UNITED STATES
DEPARTMENT OF THE INTERIOR
BUREAU OF LAND MANAGEMENTFORM APPROVED
OMB NO. 1004-0137
Expires: January 31, 2018**SUNDRY NOTICES AND REPORTS ON WELLS**
*Do not use this form for proposals to drill or to re-enter an abandoned well. Use form 3160-3 (APD) for such proposals.*5. Lease Serial No.
NNNM26394

8. Well Name and No.
VACA DRAW 20-17 FEDERAL 1H9. API Well No.
30-025-44135-00-S110. Field and Pool or Exploratory Area
WILDCAT; WOLFCAMP11. County or Parish, State
LEA COUNTY, NM**SUBMIT IN TRIPLICATE - Other instructions on page 2**

Cimarex Energy respectfully requests approval to change the Casing Program, Cement Design and Mud Program for the Vaca Draw 20-17 Fed #1H well. Cimarex also proposes utilizing a multi-bowl wellhead.

Cactus Multi-Bowl Wellhead Steps:

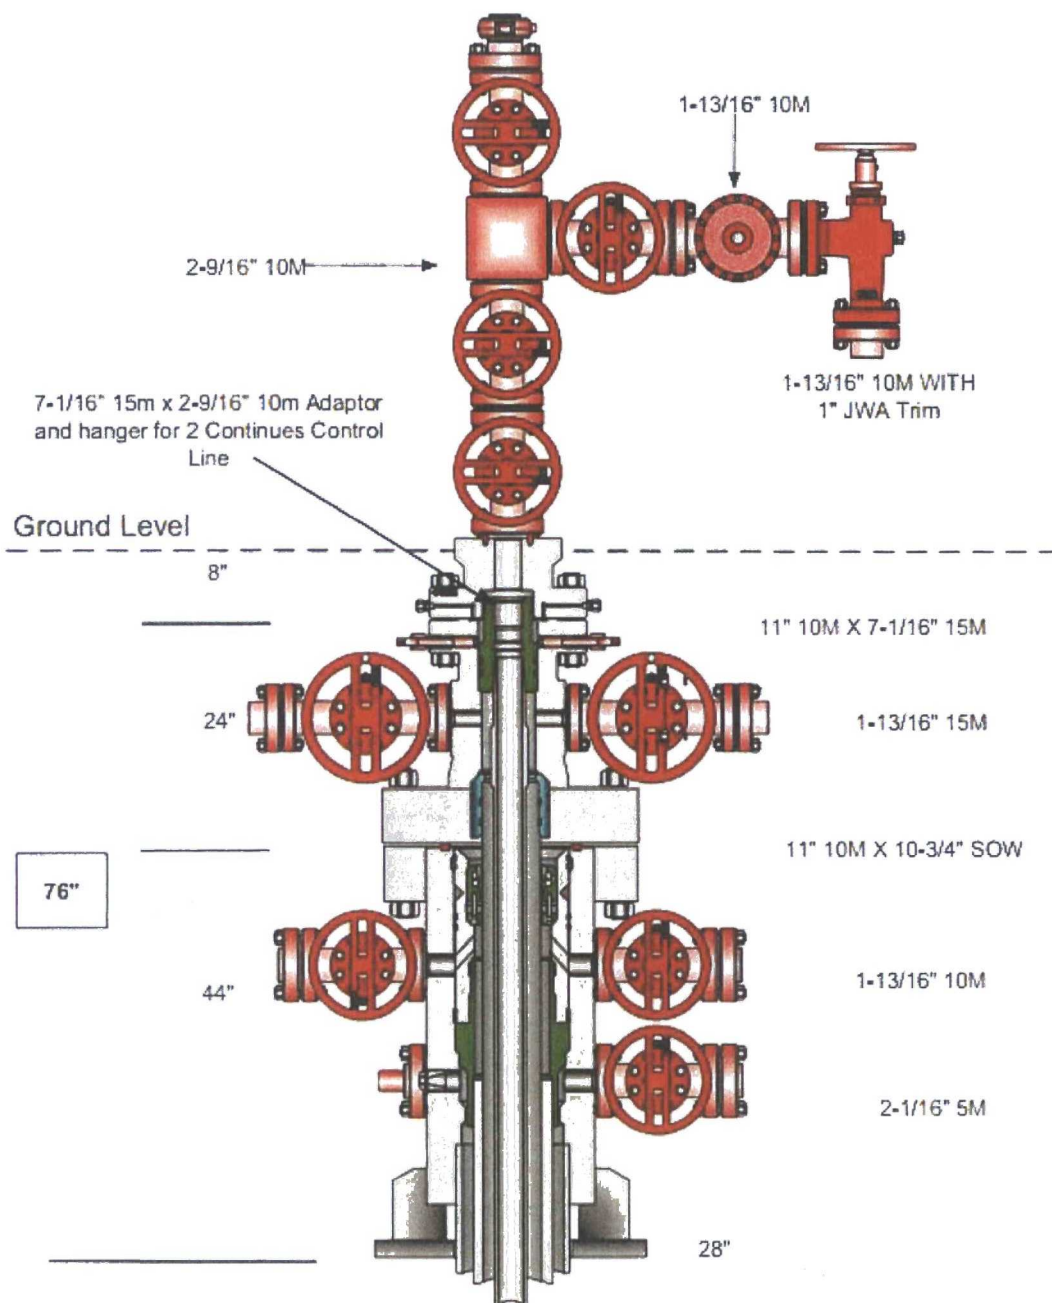
Cimarex will utilize a multi-bowl wellhead system. Please see attached diagram and procedure.

A multi-bowl wellhead system will be utilized.

A solid steel body pack-off will be utilized after running and cementing the intermediate casing. After installation the pack-off and lower flange will be pressure tested to 10000 psi.

The casing string utilizing steel body pack-off will be tested to 70% of casing burst.

4. If the operator has proposed a multi-bowl wellhead assembly in the APD. The following requirements must be met:
 - a. Wellhead shall be installed by manufacturer's representatives, submit documentation with subsequent sundry.

- b. If the welding is performed by a third party, the manufacturer's representative shall monitor the temperature to verify that it does not exceed the maximum temperature of the seal.

- c. Manufacturer representative shall install the test plug for the initial BOP test.
 - d. If the cement does not circulate and one inch operations would have been possible with a standard wellhead, the well head shall be cut off, cementing operations performed and another wellhead installed.
